March 10, 1994

Re: Request for Approval Regarding Proposed Monitoring Well MW-23D and Newly Identified Delegrade Supply Well, Southeast Area of Tutu Well Site, St. Thomas, Virgin Islands.

BY	APPR.	PROPOSED PHASE II REMEDIAL INVESTIGATION MONITORING WELL, SITE INSPECTION, AND SOIL-GAS SURVEY LOCATIONS TUTU WELLS SITE ST. THOMAS, U.S. VIRGIN ISLANDS	FIGURE 7-1 REVISED

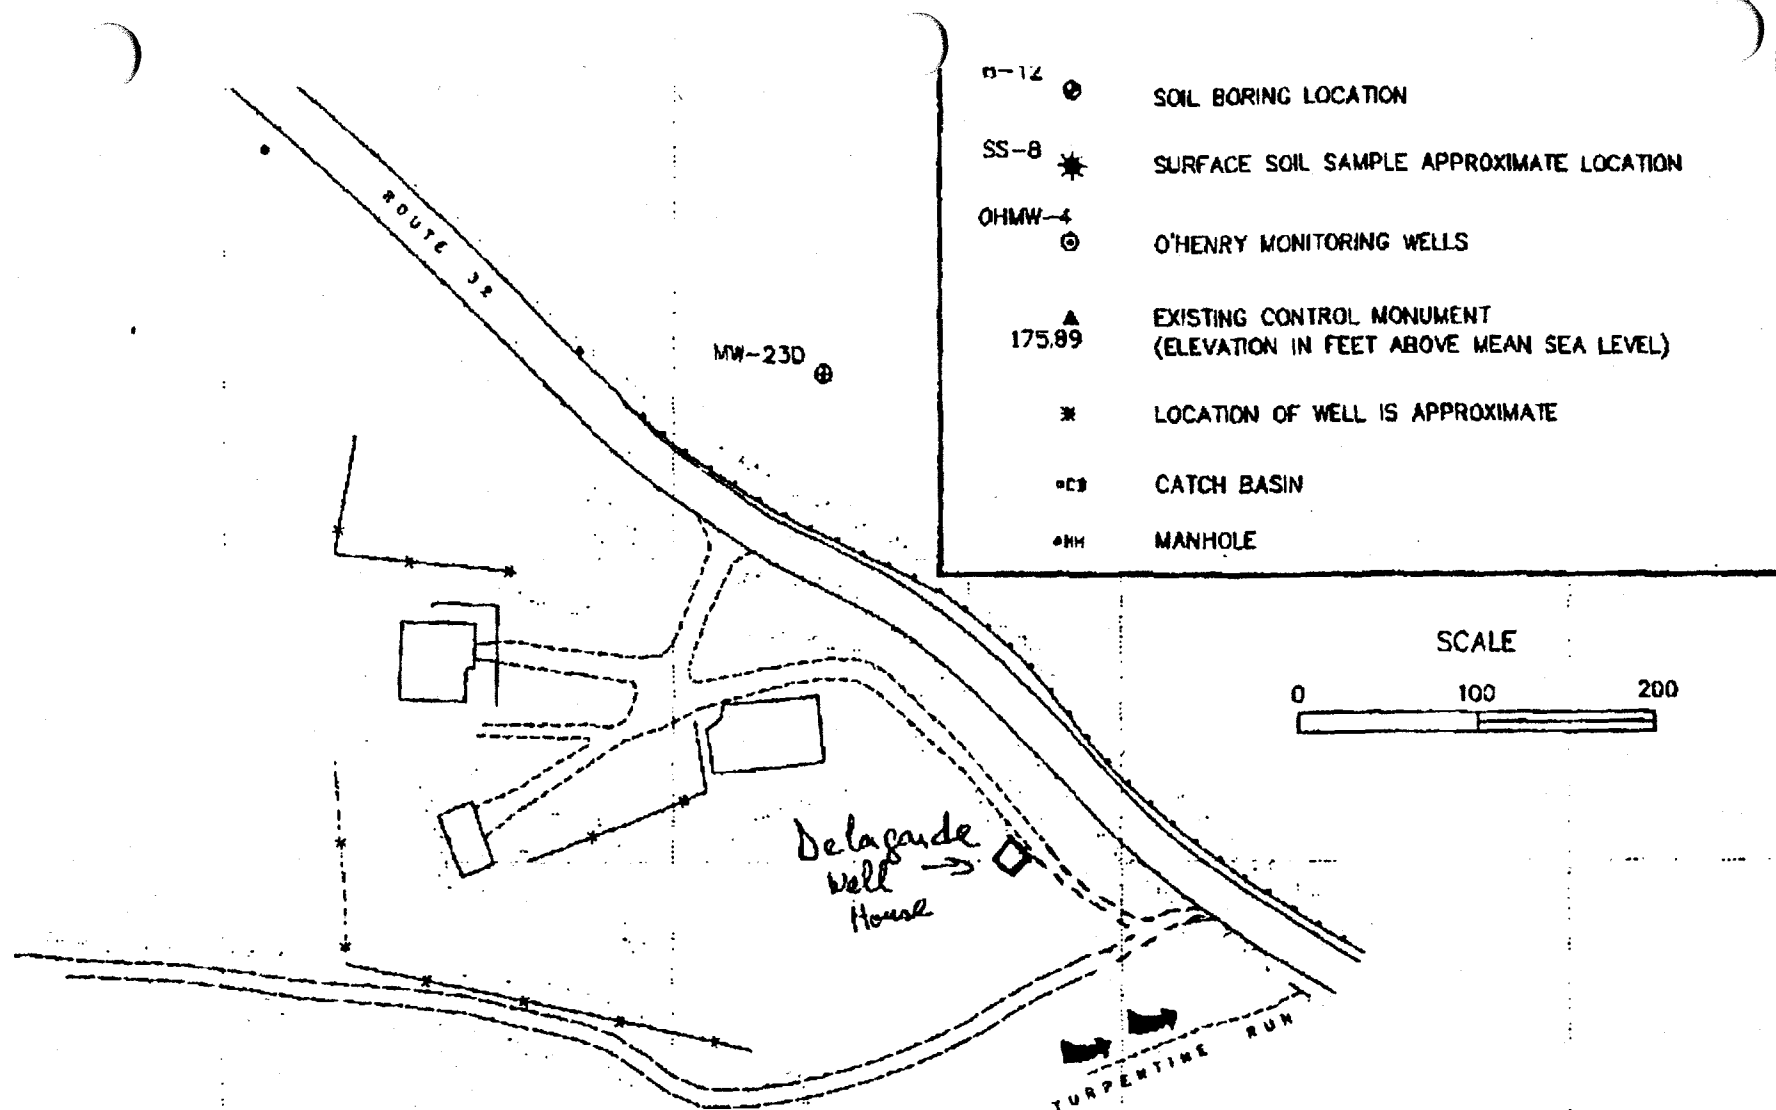
In Geraghty & Miller Inc.'s Phase II Remedial Investigation (RI) Work Plan, Tutu Wells Site, St. Thomas, U.S. Virgin Islands, dated December 1993, deep Monitoring Well MW23-D was proposed along a ravine which is the surface expression of a NW-SE trending fracture linement. The purpose of this monitoring well was to delineate the downgradient extent of the southern chlorinated volatile organic compound (VOC) plume. On behalf of Ana Gloria Ramos, Designated Coordinator of the Tutu Environmental Investigation Committee (TEIC), Geraghty & Miller is requesting a modification to the Phase II (RI) Work Plan with respect to this proposed monitoring well.

Legal access to the proposed location of this well has not been obtained due to the lack of response by the landowners to Geraghty & Miller, Inc's requests for access. Also, the physical location of the proposed monitoring well is blocked by a guardrail and woods. The only other access route would require crossing the Turpentine Run.

In a recent U.S. Geological Survey Report (Steiger, J.I. and Kessler, R., 1993; copy enclosed), a domestic supply well (Delegrade) is identified approximately 280 feet southeast of proposed Monitoring Well MW-23D (see enclosed figure). The Delegrade supply well is

reported to be 70 feet deep; the surface elevation at the well is reported as 70 feet above mean sea level (msl). The bottom of this supply well would be at approximately sea level. The proposed depth of Monitoring Well MW-23D was to be 60 feet below land surface with a 20-foot long open interval from 40 to 60 feet below land surface. Land surface elevation at the proposed location of Monitoring Well MW-23D is approximately 72 feet above msl. The bottom elevation of this proposed monitoring well would be at approximately 12 feet above msl. The Delegarde supply well, then, is an appropriate alternative to the installation of Monitoring Well MW-23D.

The TEIC and Geraghty & Miller are proposing to eliminate the installation of MW-23D from the Phase II RI and incorporate the Delegarde supply well into the supply well inspection and groundwater sampling program. We request your approval of this modification. If you have any questions, please call.
